# AGENDA

## January 20, 2011 Standards Committee Meeting

RE: Agenda for the January 20, 2011 Standards Committee Meeting

PROPOSED SOLUTION: Delete Standard Drawings listed below; add Standard Drawing listed below; revise appropriate Design Manual text and add and delete figures as listed below. Retain detail now on Standard Drawing 601-MPPG-02.

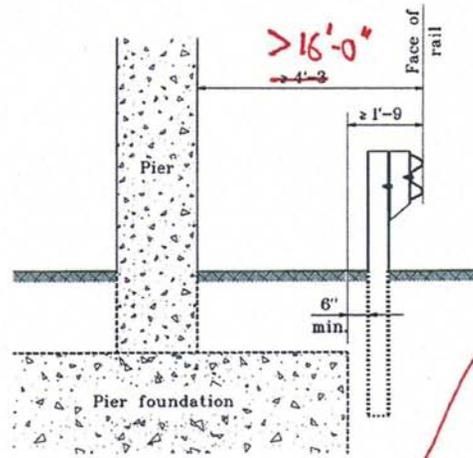
VARIATION OF THIS DETAIL TO NEW STD DWG E 601-GRBS-01

Guardrail to Pier Clearance

The detail shown on Standard Drawings 601-MPPG-02, 601-RPPG-03, and 601-RPPG-06 will be retained as a standard detail, now on new Standard Drawing 601-GRBS-01.

VARIAION OF TABLE DATA TO NEW IDOT FIG 49-4E (1)

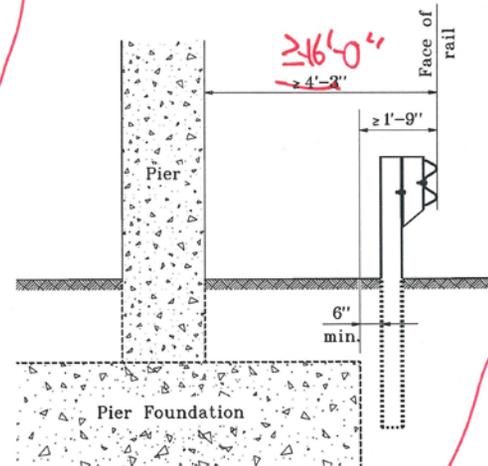
NOTES ARE DESIGN-RELATED

VARIAION OF THIS DETAIL TO NEW STD DWG E 601-8GRS-01

**BRIDGE-RAILING-END PROTECTION REQUIREMENTS****Figure 49-9A**

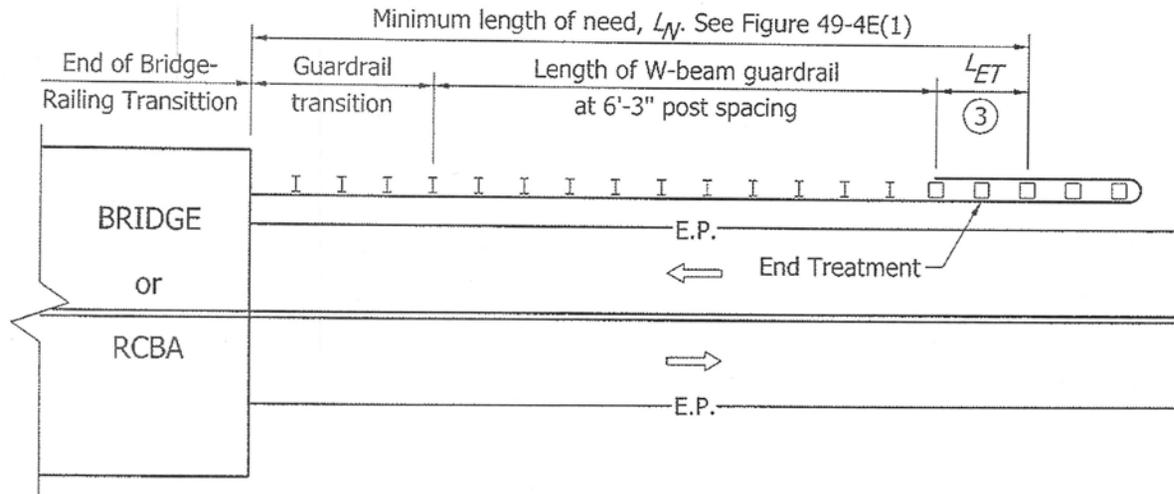
DELETE, AS TABLE DATA RESEMBLE,  
SO ARE THEREFORE SUPERSEDED,  
BY DATA IN NEW FIG 49-4E (1)

*minimum extent of protection should be in accordance with ~~Figure 49-9A, Bridge Railing-End Protection Requirements~~ as shown in Figure 49-4E(1), Minimum Guardrail Length Required in Advance of Hazard. Conditions in an urban area can preclude the protection as shown in Figure 49-4E(1). See LRFD Bridge Design Specifications Article 13.7.1.2 and its Commentary for other options.*

601-BAGR-02 MEDIAN BRIDGE APPROACH GUARDRAIL (PROPOSED TO DELETE)

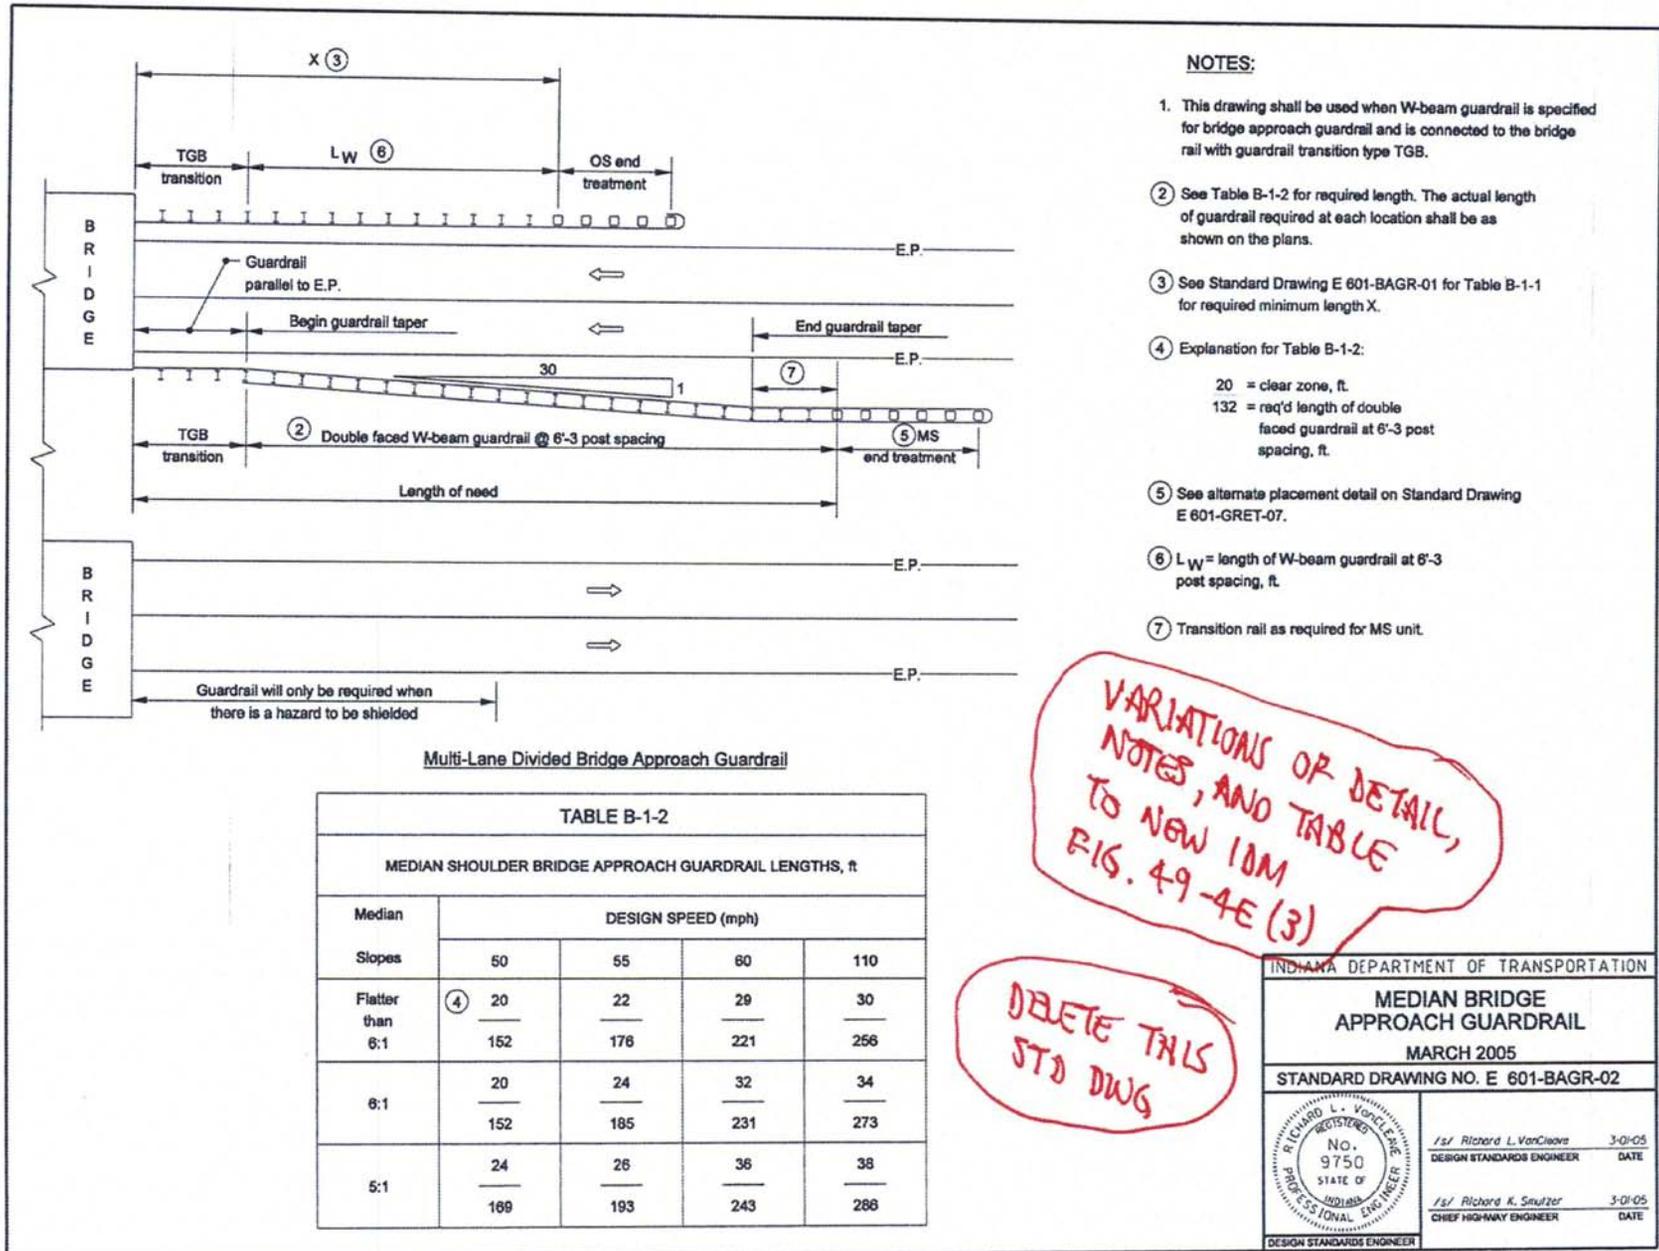
*VARIAIONS OR DETAIL, NOTES, AND TABLE TO NEW IOM FIG. 49-4E (3)*

601-RPPG-04 ROADSIDE PIER PROTECTION GUARDRAIL (PROPOSED TO DELETE)

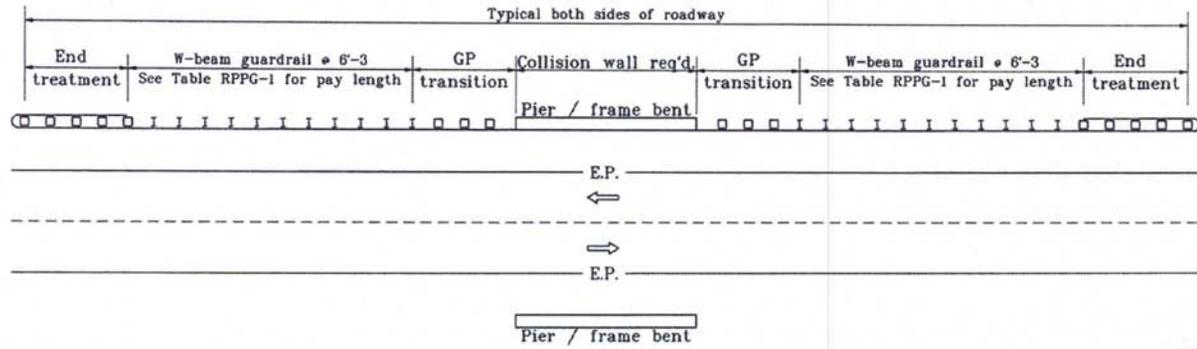
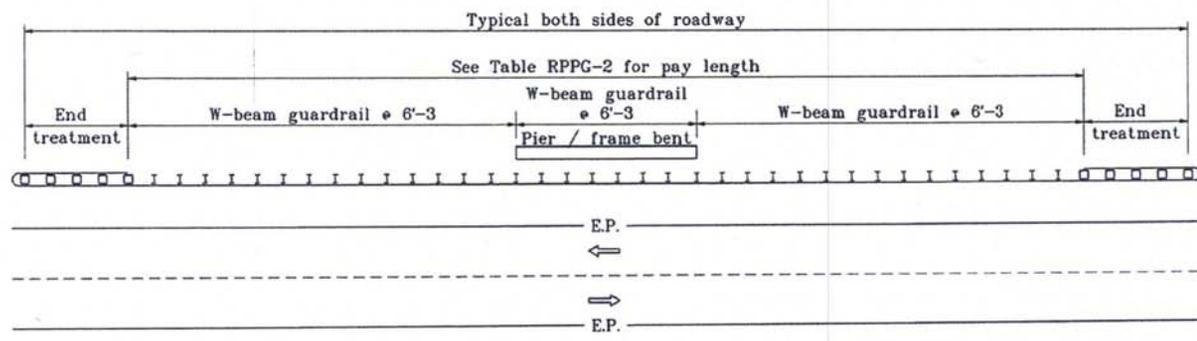
**DELETE THIS STD DWG**

**NOTES ARE DESIGN-RELATED**

**VARIATIONS OR DETAILS TO NEW IDM R16 49-4E(4)**

601-RPPG-05 ROADSIDE PIER PROTECTION GUARDRAIL (PROPOSED TO DELETE)

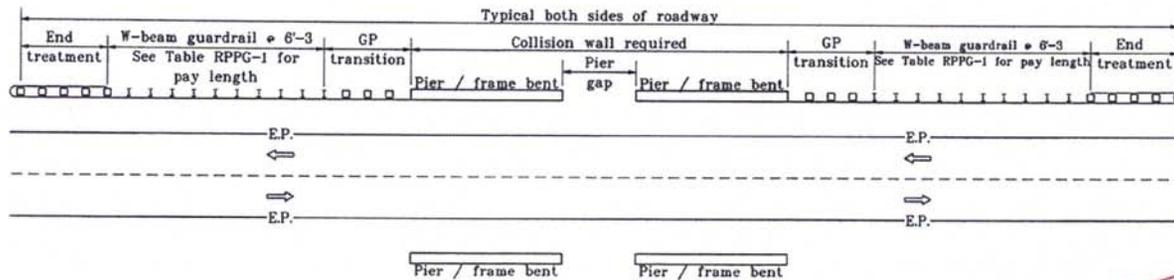
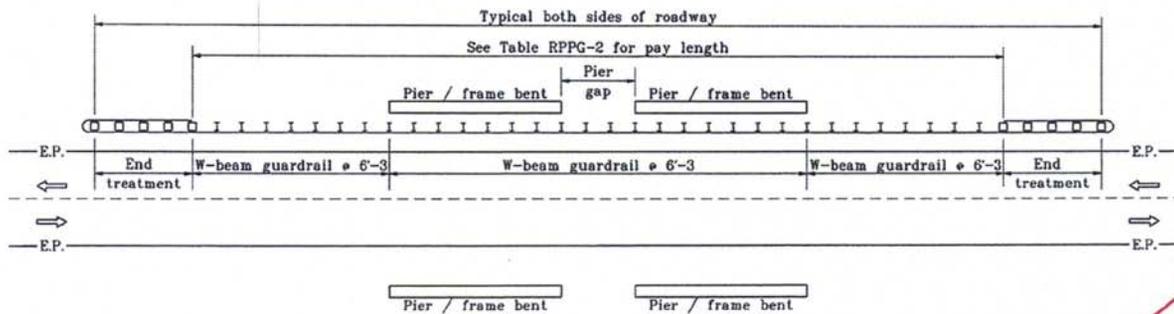
*DELETE THIS STD DWG*

*VARIATIONS OR DETAILS TO NEW 10M RIG 49-4E(S)*

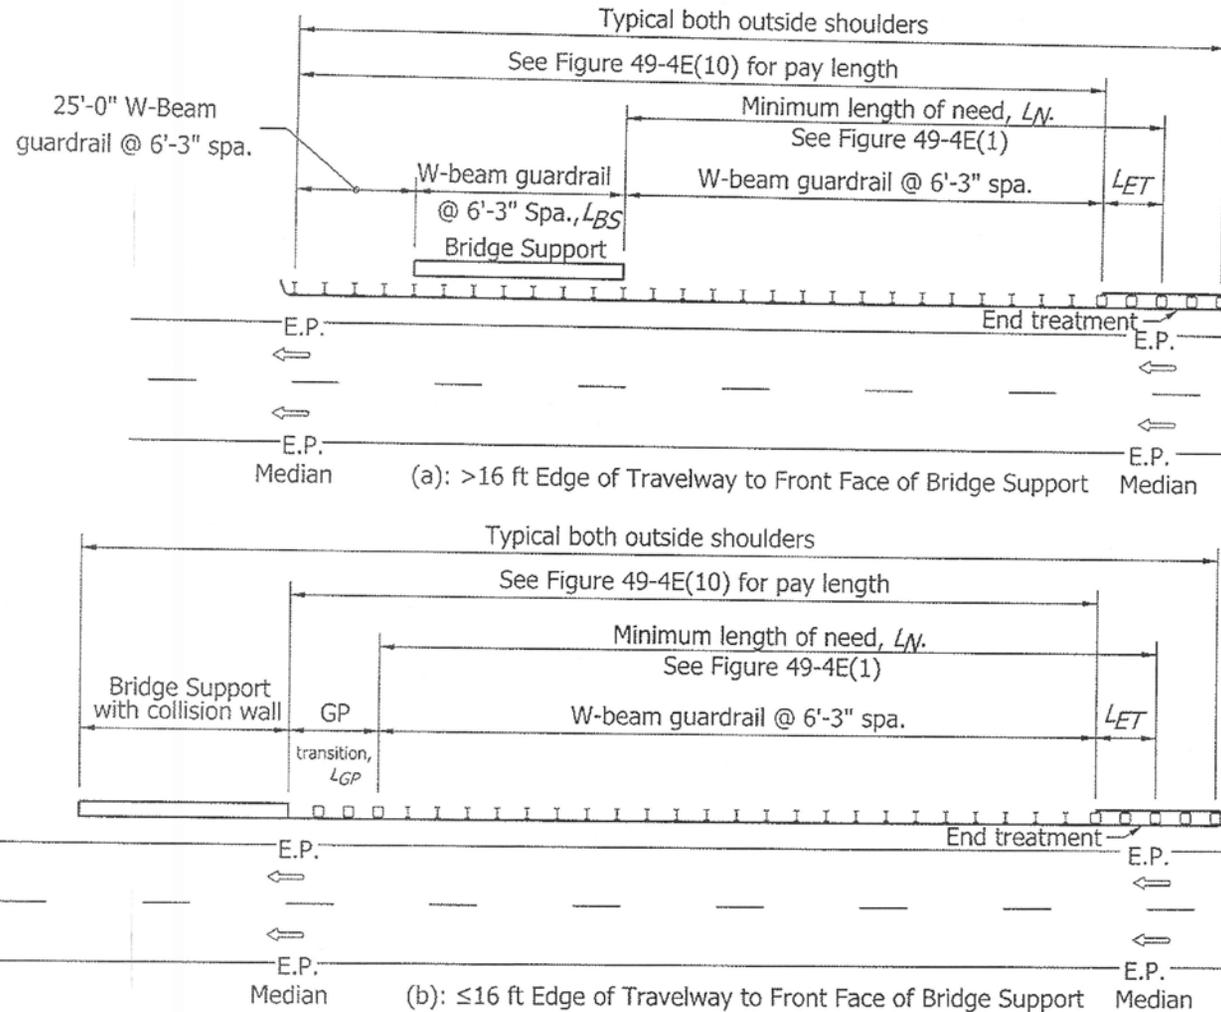
THIS NOTE IS ADDRESSED ON NEW STD DWG E 601-GRBS-01

601-RPPG-02 ROADSIDE PIER PROTECTION GUARDRAIL (PROPOSED TO DELETE)

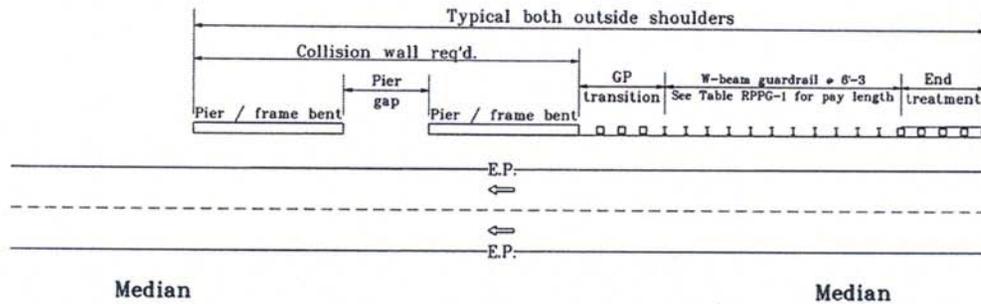
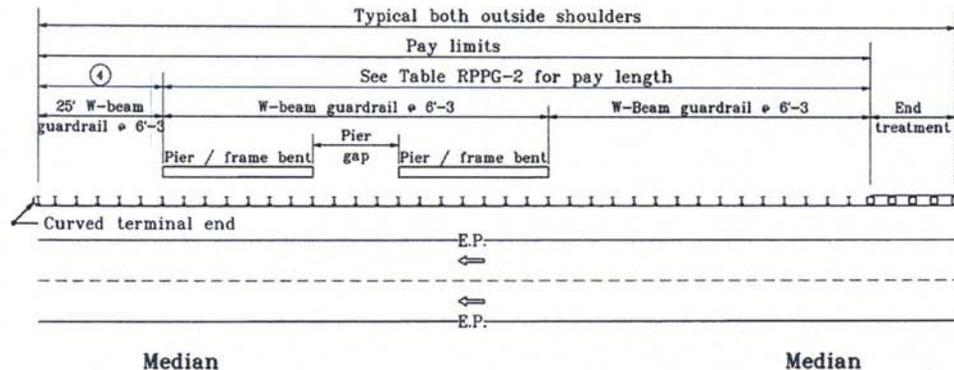
THIS NOTE IS ADDRESSED IN NEW STD DWG E 601-GRBS-01

DELETE THIS STD DWG

NOTES ARE DESIGN-RELATED

601-MPPG-03 MEDIAN PIER PROTECTION GUARDRAIL (PROPOSED TO DELETE)

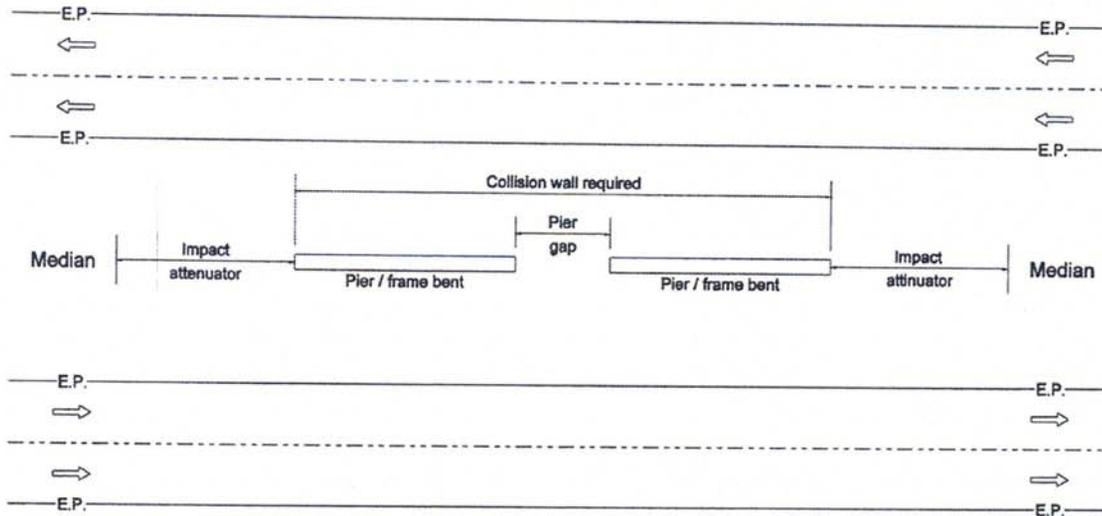
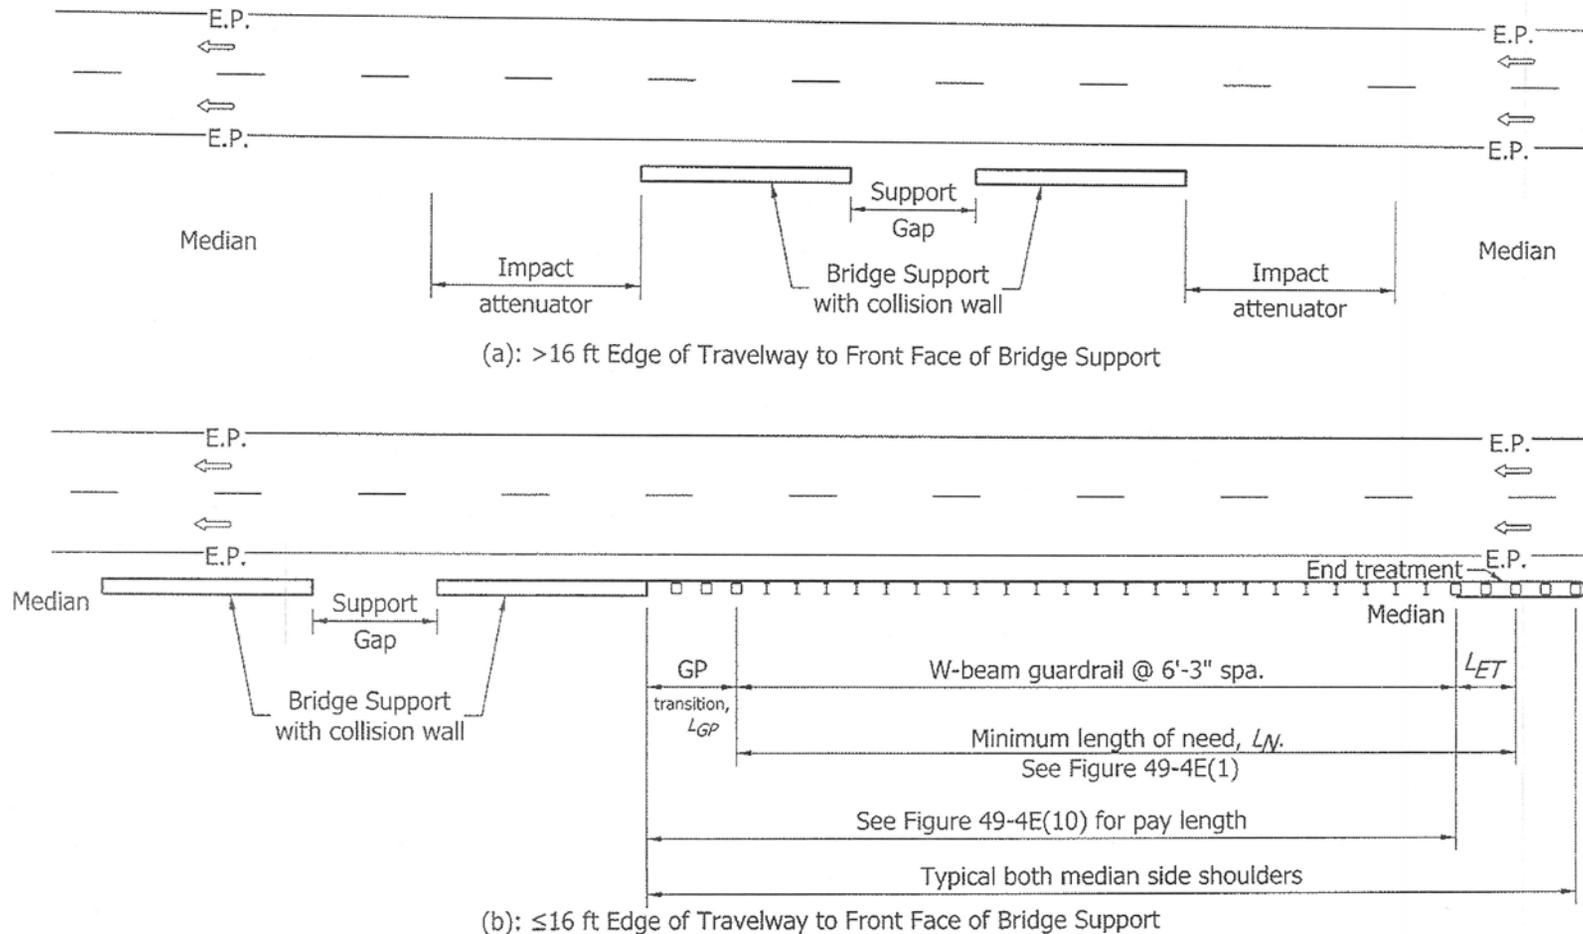
*NOTED ARE DESIGN-RELATED*

*DELETE THIS STD DWG*

*VARIATION OF DETAIL TO NEW IDOT RIG 49-4E(9), DETAIL (a)*

601-GRBS-01 GUARDRAIL AT BRIDGE SUPPORT (PROPOSED NEW, SHOWN PART 2)

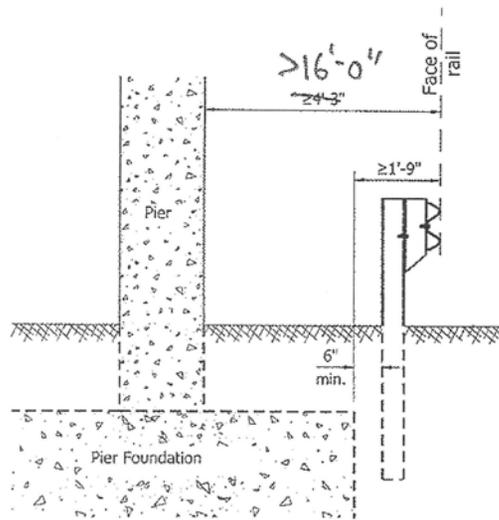
~~DOWNSSTREAM GUARDRAIL TREATMENT~~

INCLUDE ON  
 NEW STD DWG THAT  
 ADDRESSES NOTE ④ ON  
 DWG 601-RDPG-01
